Appl. No. : 09/605,282  
Filed : June 28, 2000

# REMARKS

## Objection To The Drawings

## Changes to the Drawings

FIG. 1

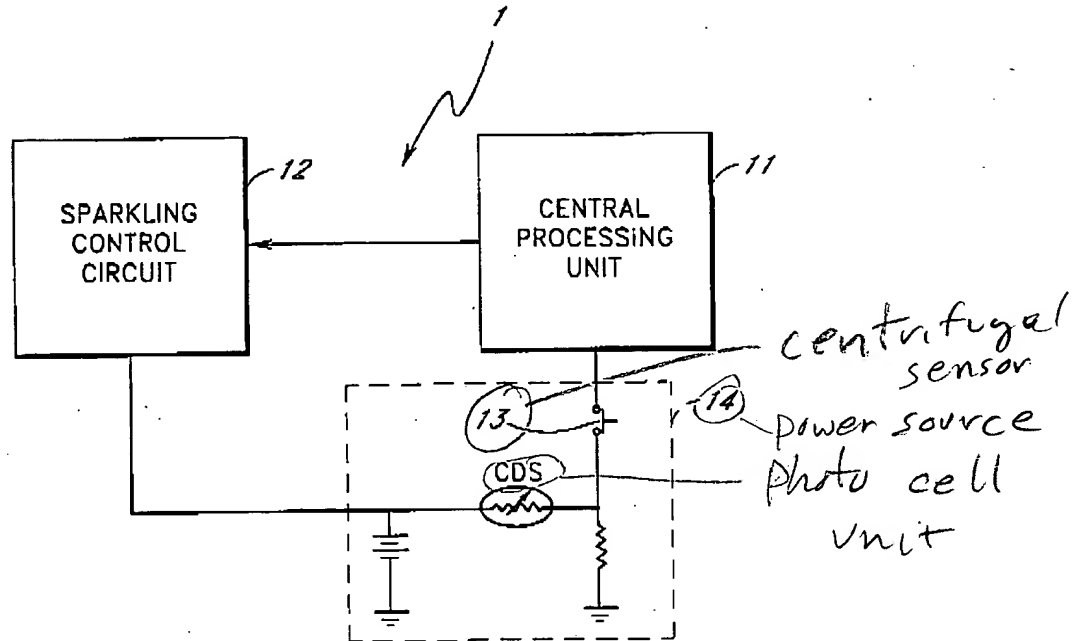
Applicant has amended Figure 1 to delete the words "Power Source" under reference numeral 14. No new matter has been added, as the specification already identifies reference numeral 14 with a power source. See Page 4, line 8.

FIG. 2

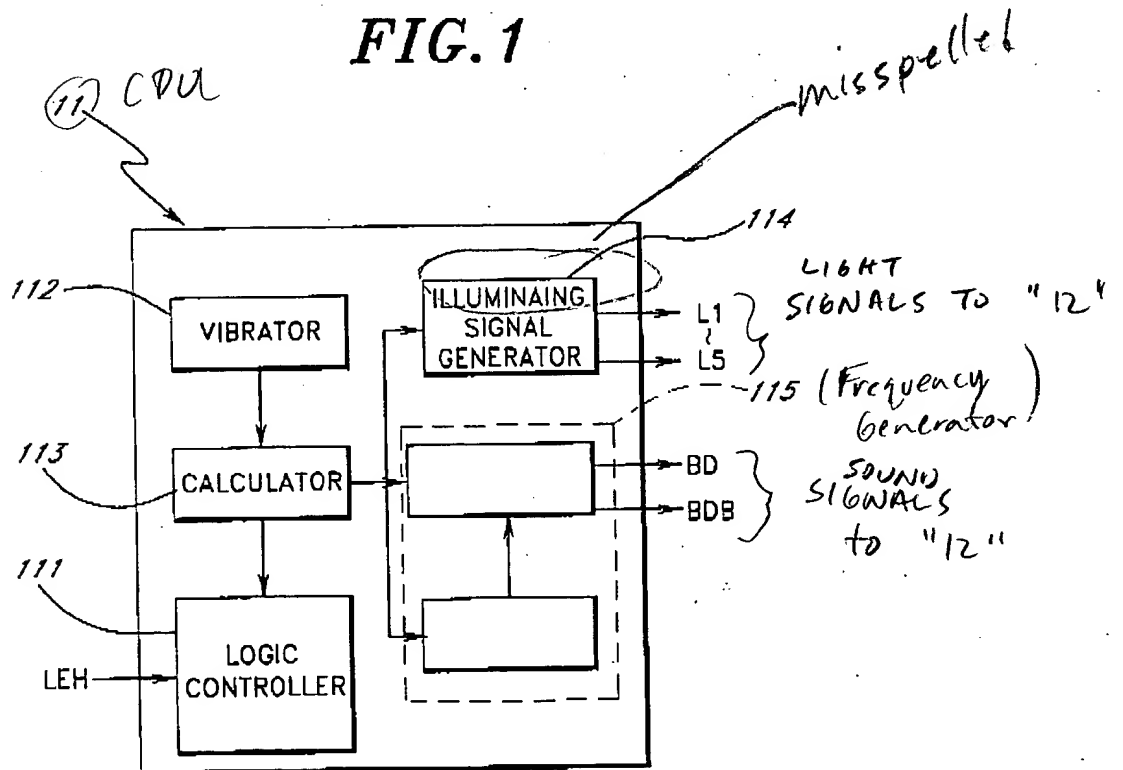
The Examiner also objected to the drawings under 37 C.F.R. § 1.84(p)(5) for not including "the following reference sign(s) mentioned in the description: a) no 'LED' shown in Fig. 2 as set forth in line 29, page 4; b) no centrifugal sensor '13' shown in Fig. 5 as set forth in line 13, page 5; c) Figs 6 and 7 show sparkling lights 'L1 to L5' and not 'L1 to L2' as set forth in line 25, page 5; d) there is no mounting groove '22' shown in Fig. 6 as set forth in line 31, page 5."

In addition, the Examiner noted that "one box shown in Fig. 2 is blank without labeling or a reference numeral" and requested clarification of the purpose of this box.

Applicant has amended Figure 2 to correctly direct the lead line of reference numeral 115 to the dashed box. Applicant respectfully submits that said lead line was inadvertently and

mistakenly directed to one of the boxes inside the dashed box and that the corrected configuration does not introduce new matter. For example, the same figure in Taiwanese Application No. 88218182, a certified translation of which is included herewith and from which the above-identified application claims priority, illustrates the correct configuration of Figure 2. Thus, the changed lead line correctly associates the dashed box with the "frequency generator" identified as reference numeral 115 in the specification. Accordingly, Applicant has deleted the words "Frequency Generator" from Figure 2. Applicant respectfully submits the two boxes within the dashed box are parts of the frequency generator and function as I/O, or input/output, modules. This is supported by the specification, for example on page 4, lines 28-32, which describes the logic controller 111 as driving the frequency generator 115 and the generator 115 communicating a signal to the sparkling control circuit 12.

Applicant has also amended the specification to replace "LED" with "LEH" on page 4, line 29. As above, this amendment merely corrects a typographical error, is supported by the specification, and does not introduce new matter. For example, lines 3 to 12 of page 5 associate "LEH" with the "high position signal," as used on page 4, line 28.
